**Change Notice for Modifying Approved Documents/Workplans  
In Accordance with the Tri-Party Agreement Action Plan,  
Section 9.0, Documentation and Records**

Change Number	Document Submitted Under Tri-Party Agreement Milestone	Date:
TPA-CN-283	N/A	08/26/2009
<b>Document Number and Title:</b> <i>Removal Action Work Plan for the Northern Part of the BC Controlled Area (UPR-200-E-83) Located Within the 200-UR-1 Operable Unit (DOE/RL-2008-22, Rev. 0, June 2008).</i>		<b>Date Document Last Issued:</b> June 2008
<b>Originator:</b> O.A. Farabee, RL		<b>Phone:</b> 509-376-8089
<p><b>Description of Change:</b> Changes are made to the subject document regarding a new location for the queue/waste container storage area (queue/WCSA); references to the FS/Proposed Plan and the Health and Safety Plan (HASP);- the minimum detectable contamination (MDC) levels identified for the sodium iodide (NaI) detectors; post-removal action verification surveys and sample collection; and the schedule for excavation.</p> <p>O.A. Farabee, RL Federal Project Director and L.A. Fort, Washington State Department of Ecology Tri-Party Agreement Section <u>Manager</u>, agree that the proposed change modifies an app

# BC Controlled Area Zone A

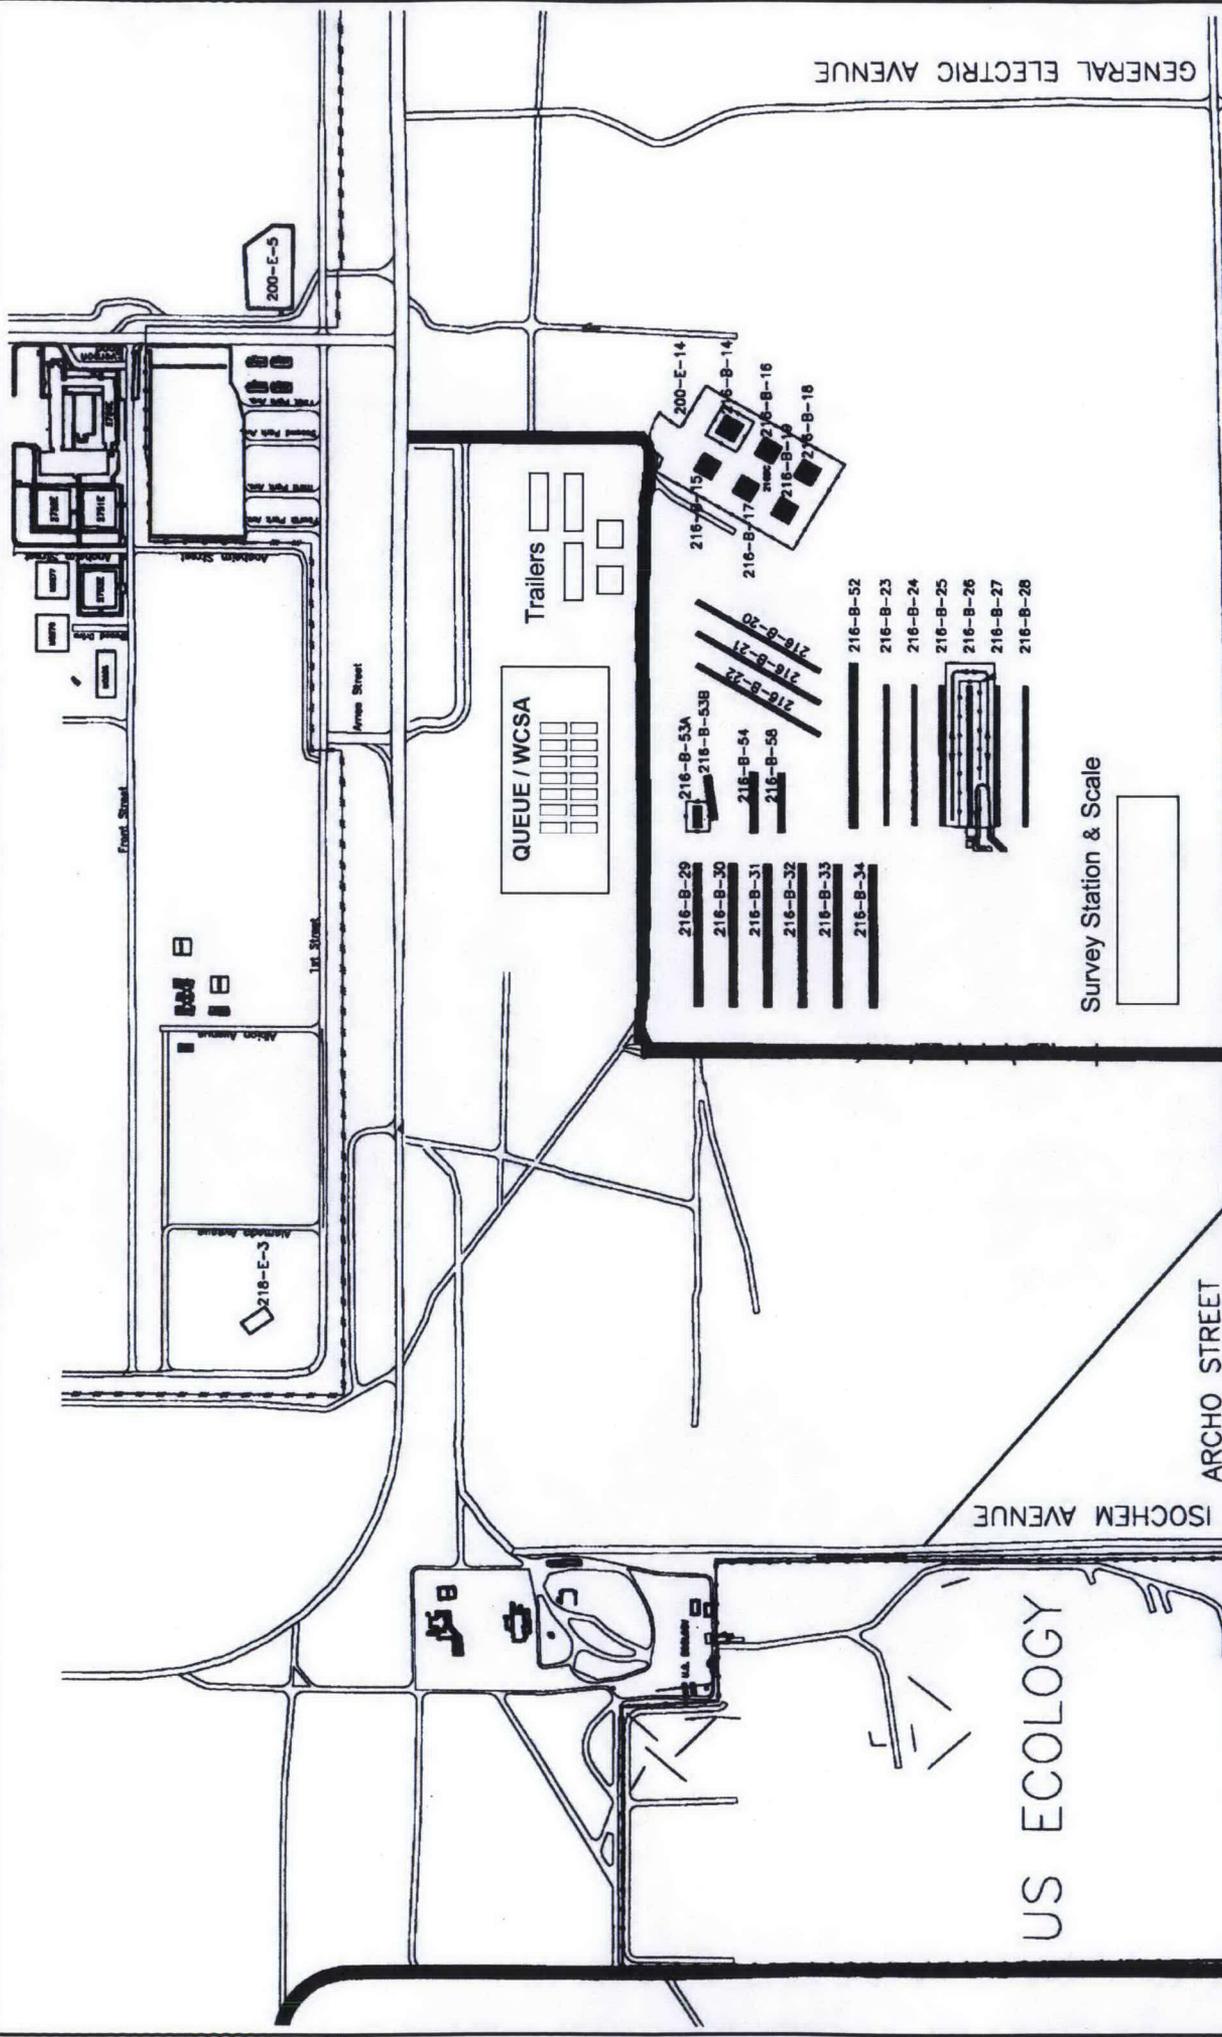
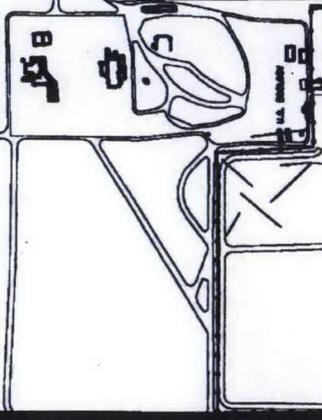
<p><b>Justification and Impacts of Change:</b></p> <ol style="list-style-type: none"> <li>1. The queue/WCSA location is relocated to an area adjacent to route 4 for ease of truck access and proximity to work area. The area is already cleared of vegetation.</li> <li>2. The reference is changed from the 200-UR-1 FS/Proposed Plan to the final ROD for this waste site because the final record of decision supersedes the FS/Proposed Plan as a decision document under the Comprehensive Environmental Response, Compensation and Liability Act. Reference to a specific HASP is deleted so that any needed changes may be made to the HASP without also causing the RAWP to be changed.</li> <li>3. Footnote "d" incorrectly referred to "remedial" action instead of "removal" action. Reference to individual isotopes is for clarification to the users. The reference to the 30 year decay period is necessary to link the derived concentration guide limits (DCGLs) to the 15 mrem close-out criteria.</li> <li>4. The minimum detectable contamination levels are added for the field detectors to show the ability of the detectors to meet the DCGLs.</li> <li>5. Field surveys are added for post-removal verification to clarify that this method may be used in lieu of sampling each location.</li> <li>6. The schedule for the cleanup activities is updated to show near term commencement of activities coincident with establishment of funding.</li> </ol> <p>These changes will be included in the next revision to <i>DOE/RL-2008-22 (Revision 0, June 2008)</i>. No impacts are identified to cost, scope or Tri-Party Agreement milestones. The RAWP schedule is updated to show excavation activities occurring from July, 2009 through December 2010.</p>

QUEUE / WCSA
